**METROPOLITAN GOVERNMENT OF NASHVILLE AND DAVIDSON COUNTY**

**STAFF RECOMMENDATION  
1801 Fatherland Street  
July 18, 2011**

**Application:** New construction—accessory building and rear addition; Partial Demolition—addition, dormer, exterior stair, and accessory structure; Setback reduction.

**A1.0**

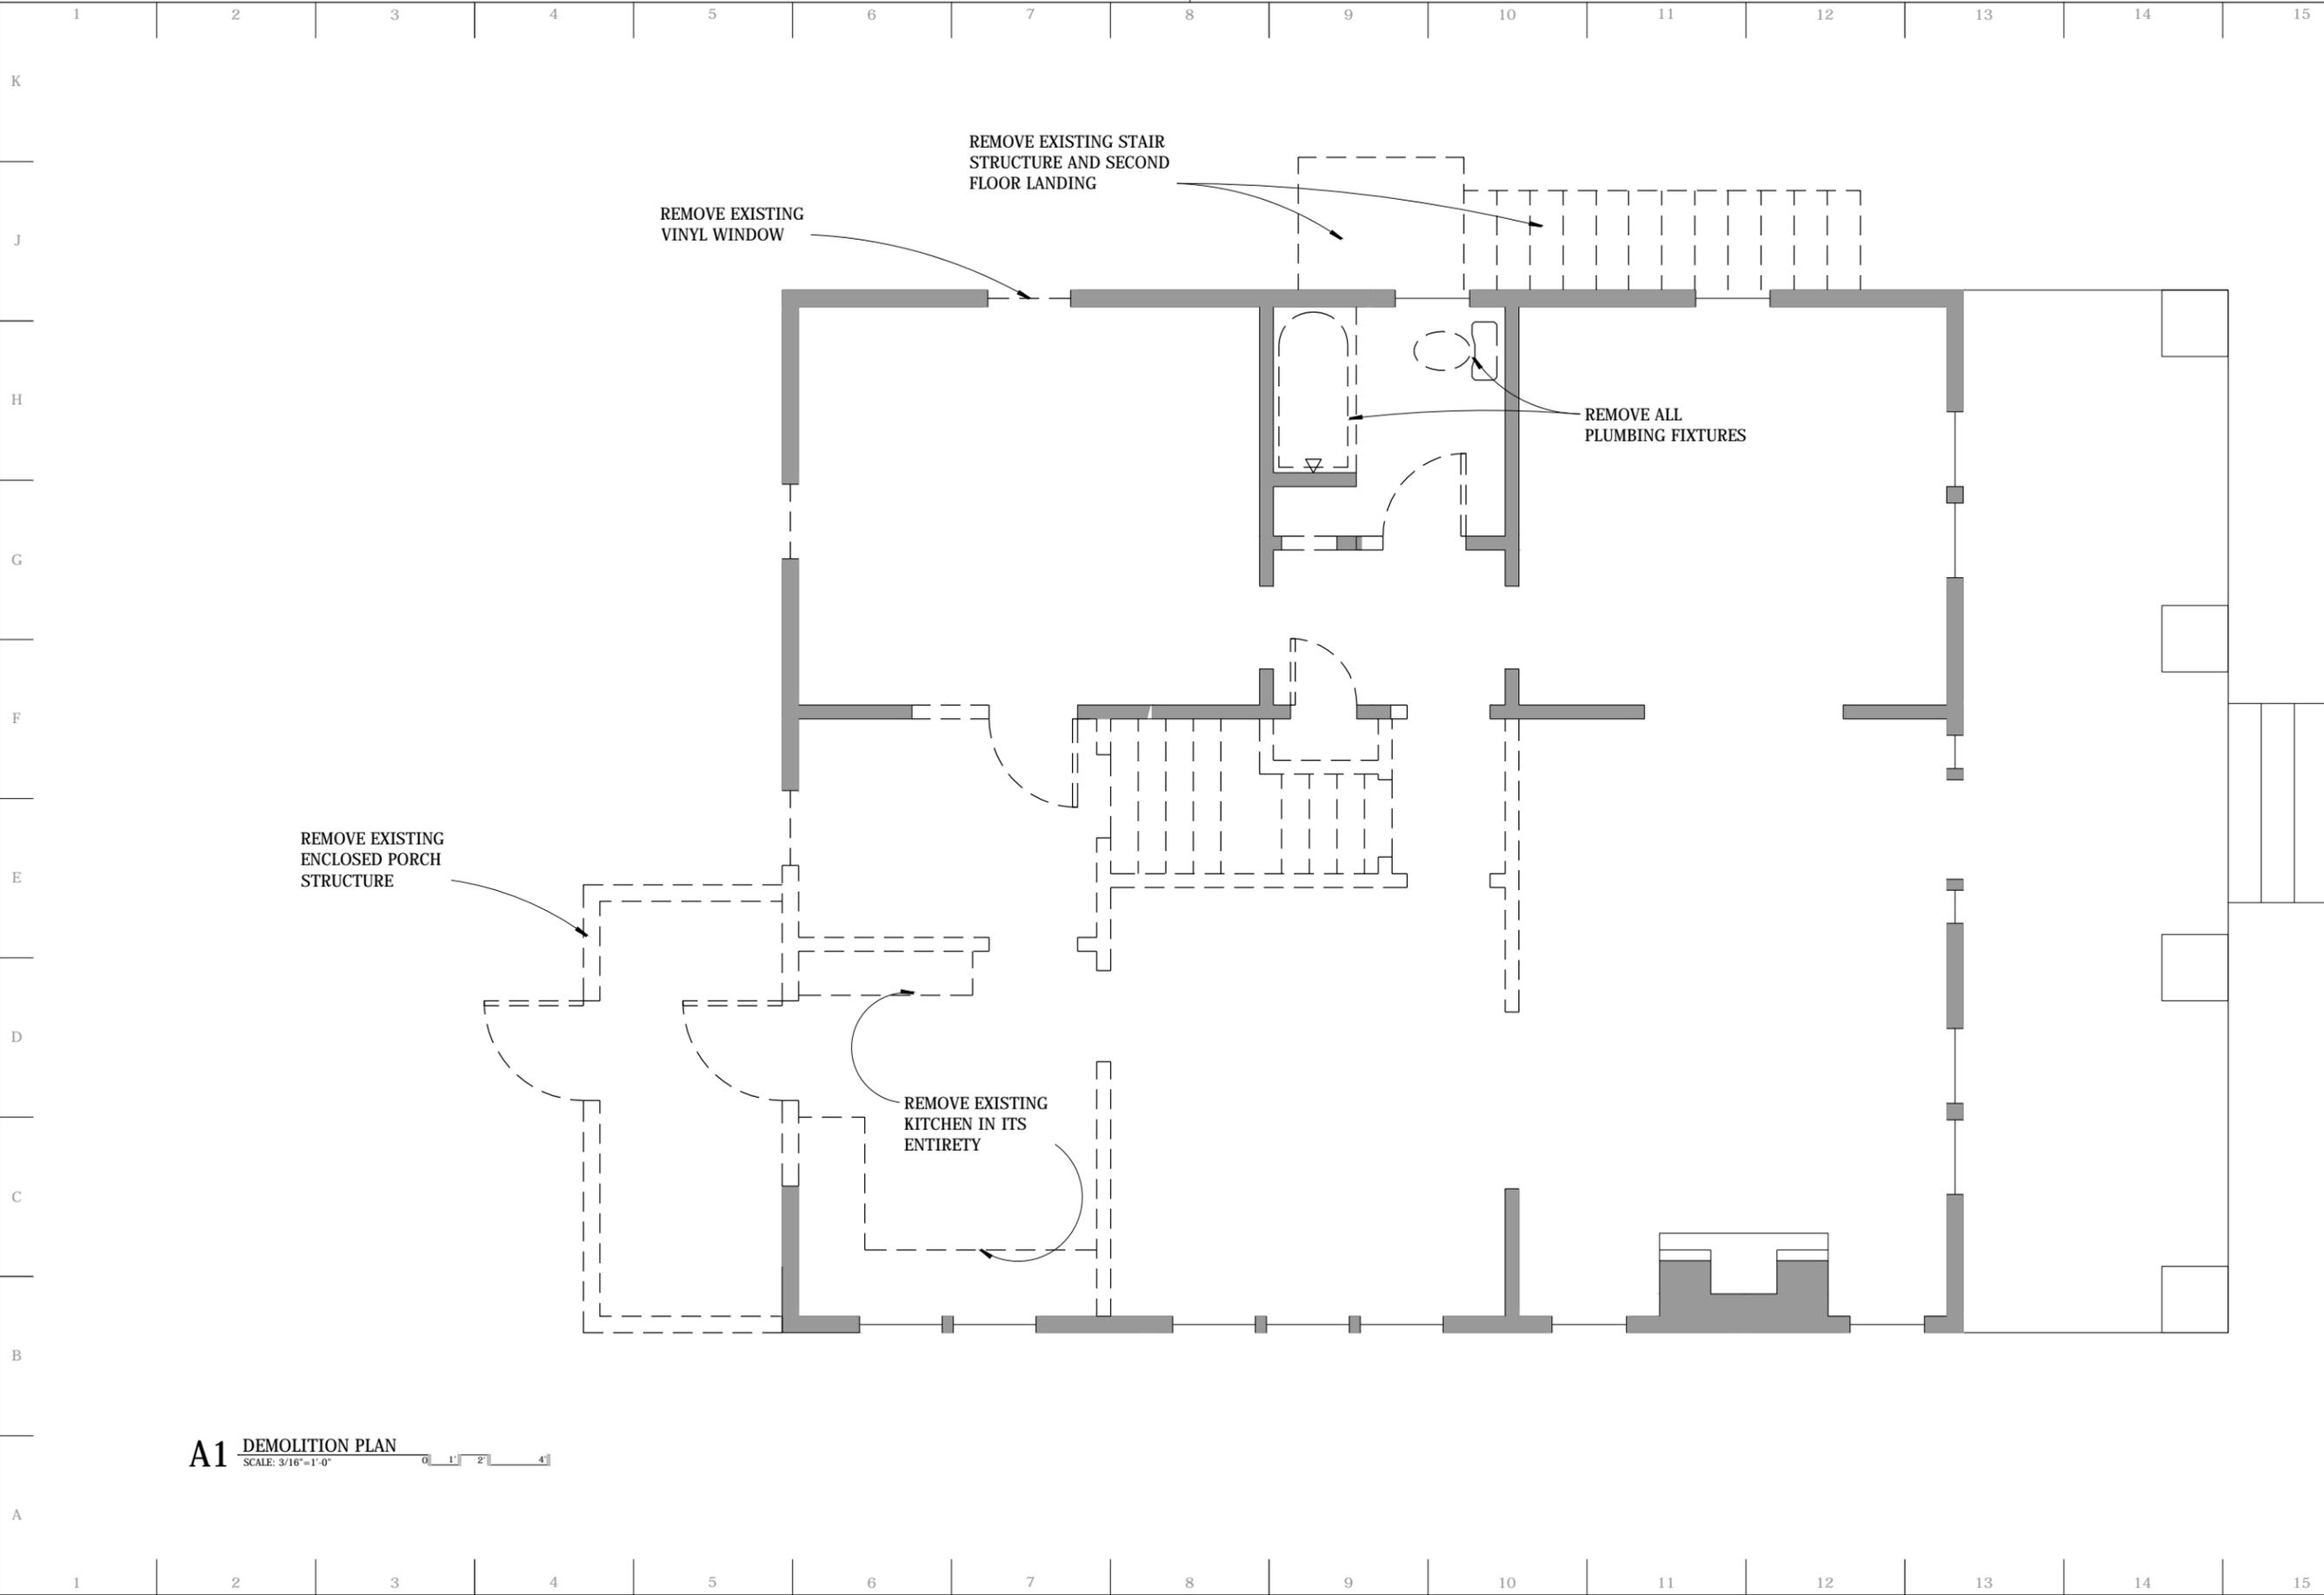
Location and Setback: The proposed rear addition meets all base zoning requirements for setbacks, and is located entirely behind the existing historic house. The proposed accessory structure, which will be discussed in detail under the “Outbuildings” section, is located in the rear of the property, with its garage doors facing the alley. It requires a reduction to the rear setback. Base zoning requires an accessory structure that has garage doors facing the alley to be ten feet (10’) from the rear property line. The applicant is proposing to situate the accessory structure just five feet (5’) from the rear property line. Staff finds the proposed reduction to the rear setback to be appropriate in this instance because historically, accessory structures were often situated closer than ten feet (10’) from the property line. In addition, there are at least three other accessory structures on this block of Fatherland Street that do not meet the required setback of ten feet (10’).

Outbuilding: A detached garage that is twenty feet wide and twenty feet deep (20’ X 20’) is proposed for the rear of the property. The garage will have vehicular doors facing the alley. As discussed in the “Location and Setback” section of the staff recommendation, a rear setback reduction is requested for the structure; the garage is proposed to be five feet (5’) from the rear property line, and base zoning requires that it be ten feet (10’) from property line. Staff finds the setback reduction to meet the design guidelines.

Staff finds the location and setback of the proposed addition and accessory structure to meet section II.B.3, II.B.8, and II.B.10.b. of the *Lockeland Spring-East End Neighborhood Conservation District: Handbook and Design Guidelines*.

A4.1

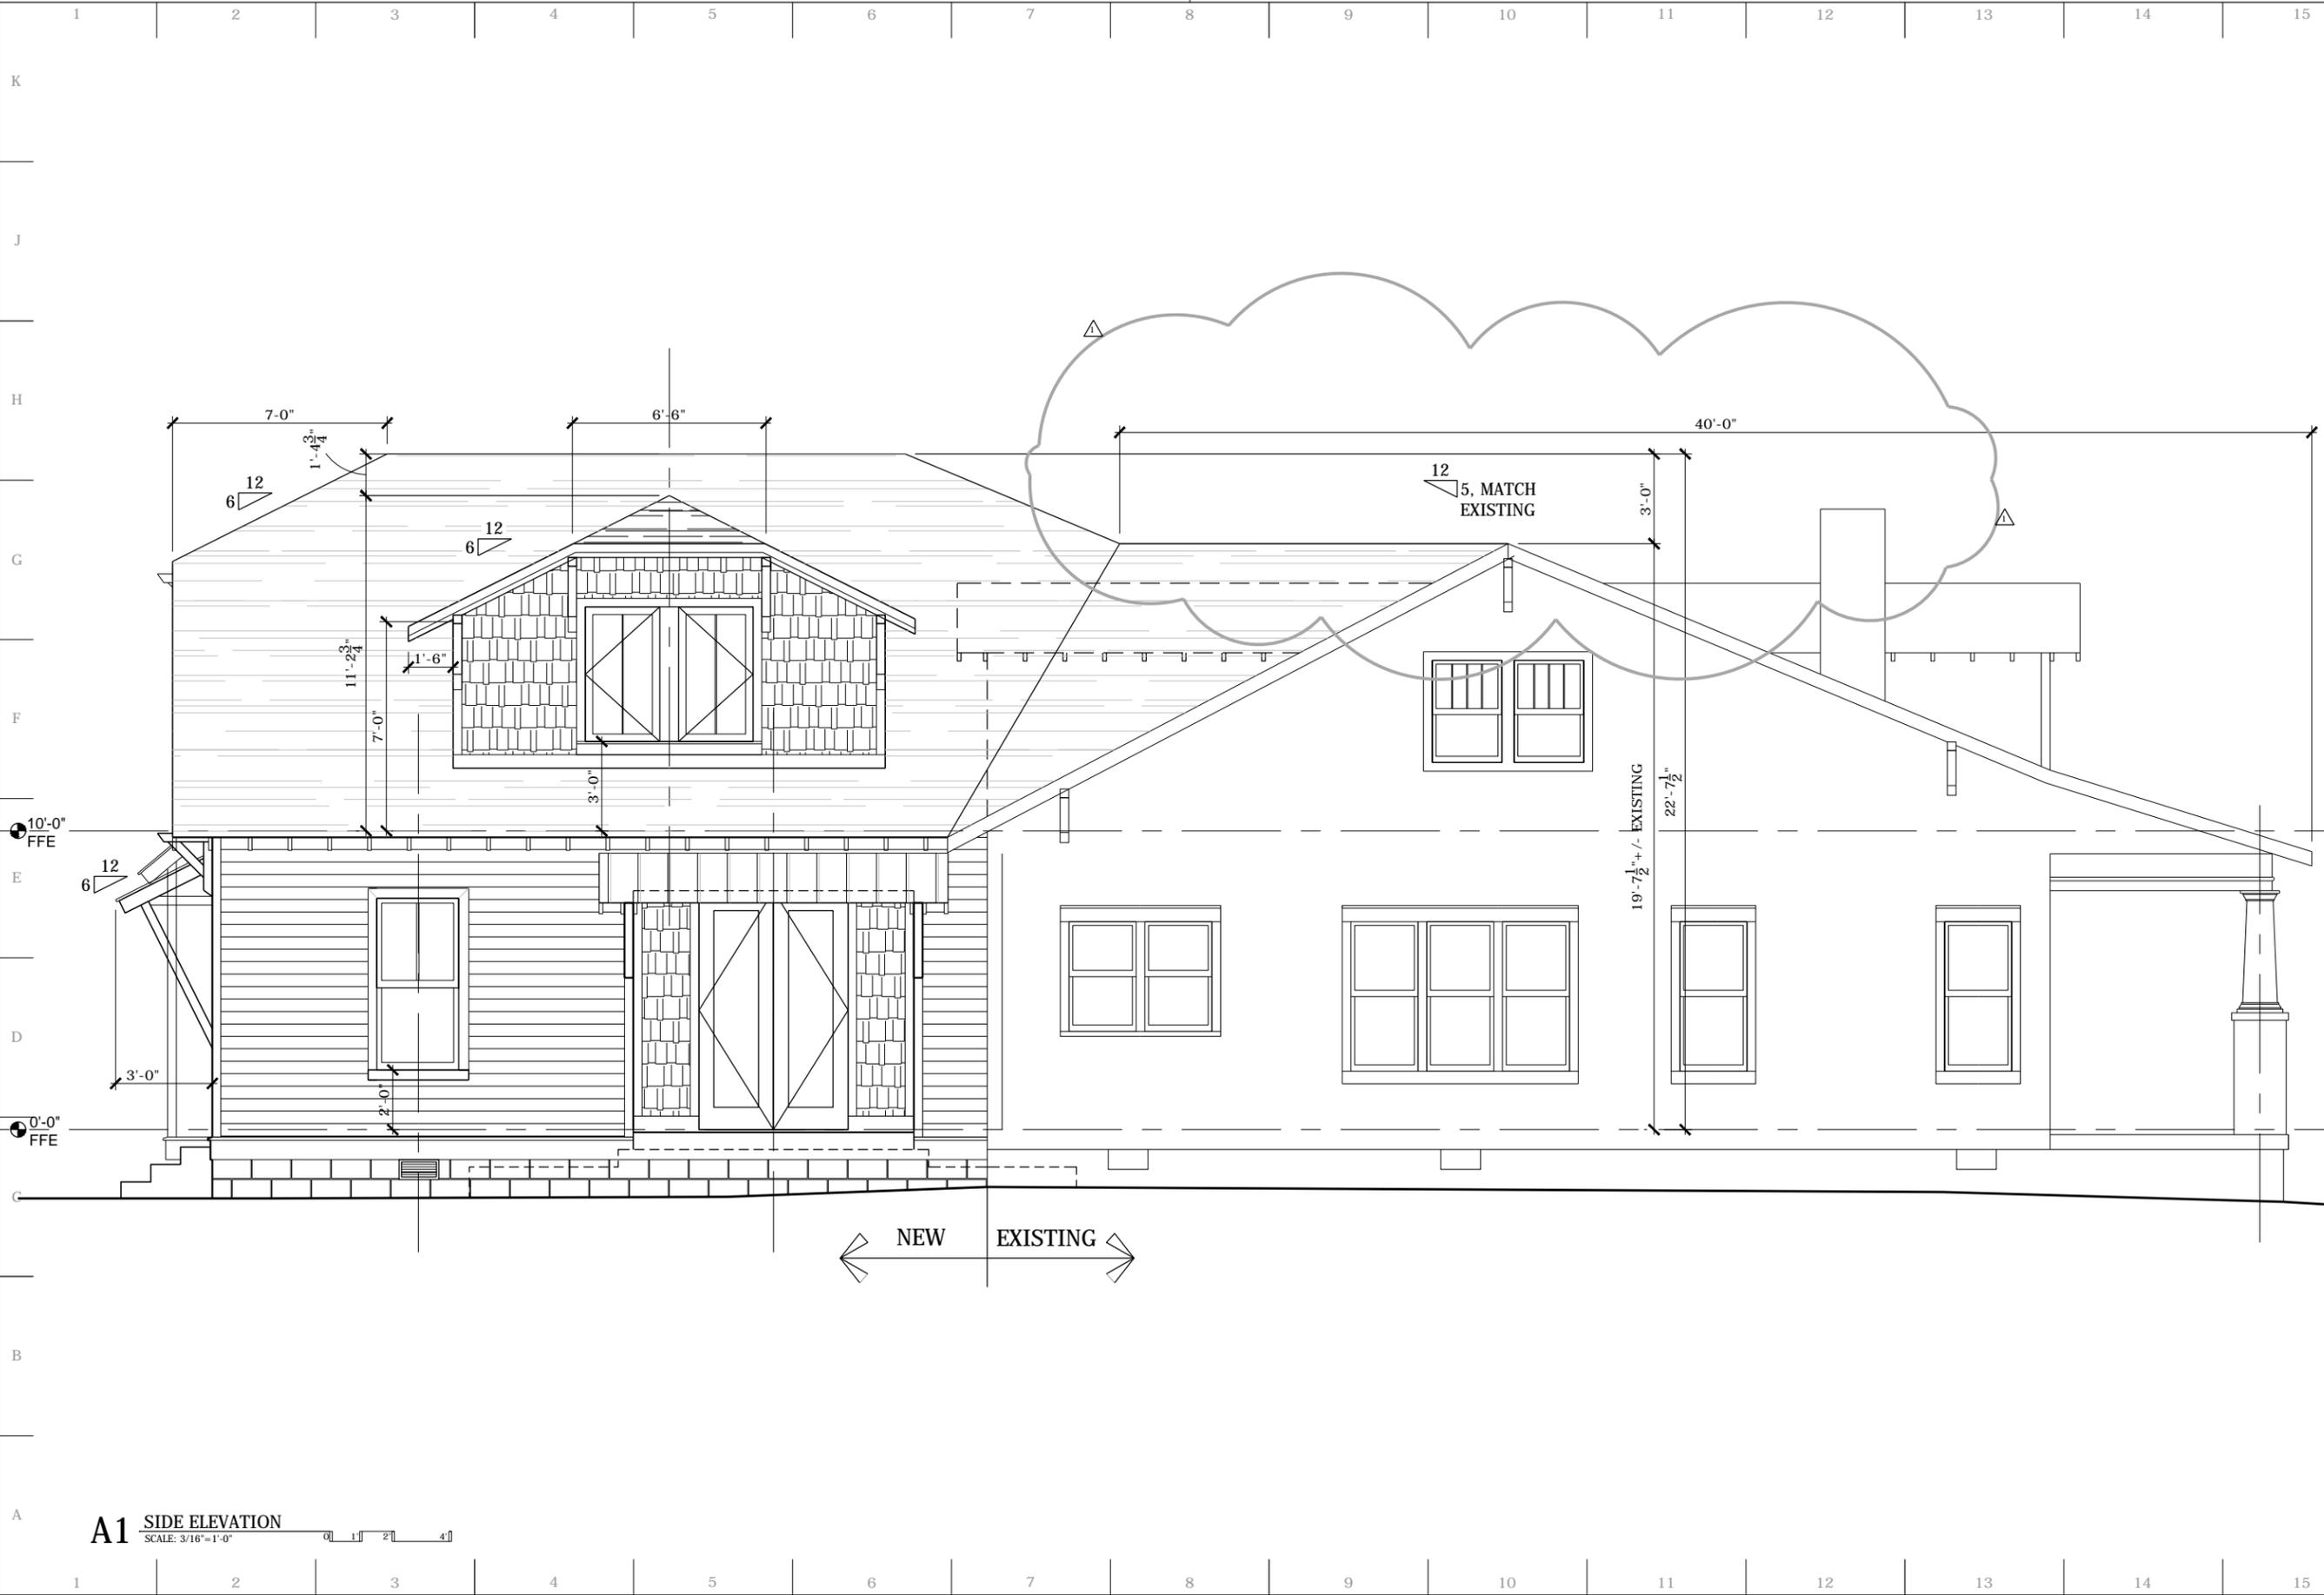
Proportion and Rhythm of Openings: The addition's proposed window openings are roughly twice as tall as they are wide, and there are no large expanses of wall space without a window or door opening. Staff therefore finds the addition's proposed proportion and rhythm of openings to meet the design guidelines. Staff noticed that the window and door openings on the right façade will be altered as part of the project. Staff asks that a condition of approval be that the applicant submit a revised right façade drawing indicating which window and door openings will be removed and which window openings are new. There did not seem to be any alterations planned for the fenestration

With the removal of the staircase, the window pattern on the right façade will be altered

With the submission of a revised right façade elevation showing the changes to the window and door openings, staff finds the project’s proportion and rhythm of openings to meet section II.B.7 and II.B.10.a. of the *Lockeland Spring-East End Neighborhood Conservation District: Handbook and Design Guidelines*.

1. Staff approve the final materials and specifications for all windows and doors.
2. The applicant submit a revised right façade elevation showing the alteration of the window and door pattern.
3. The applicant submit an elevation drawing showing the outbuilding's façade that faces the house.

**A1** ALLEY ELEVATION  
SCALE: 3/16"=1'-0"

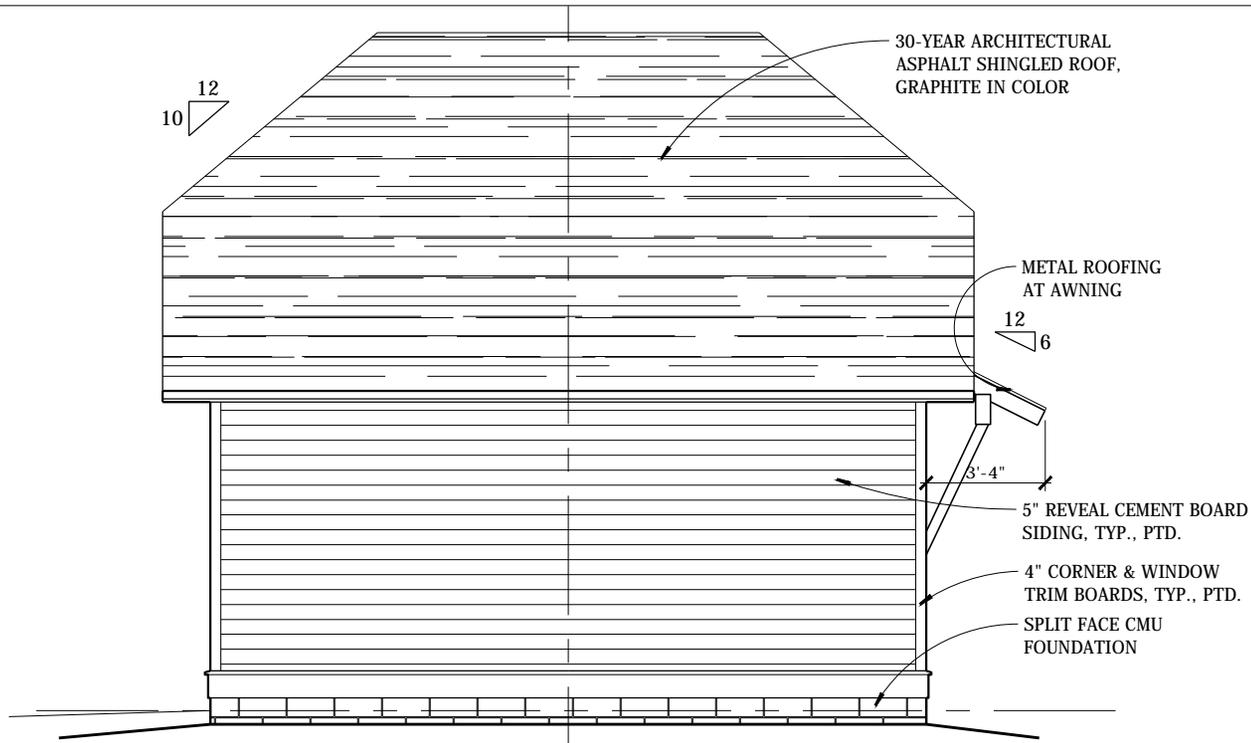
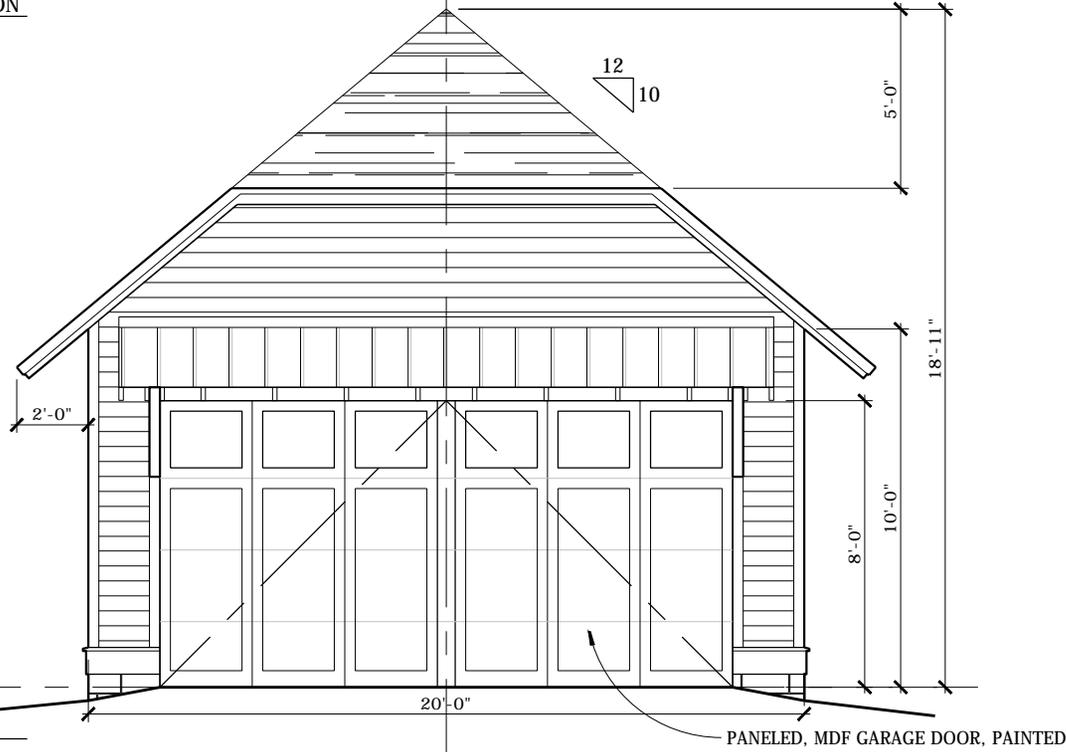
An elevation drawing showing the garage's façade that faces the house was not submitted. Staff asks that a condition of approval be that the applicant submit a drawing of this façade, as well as any plan for a pedestrian door into the structure.

With the submission of the elevation drawing, staff finds the proposed outbuilding to meet Section II.B.8. of the *Lockeland Spring-East End Neighborhood Conservation District: Handbook and Design Guidelines*
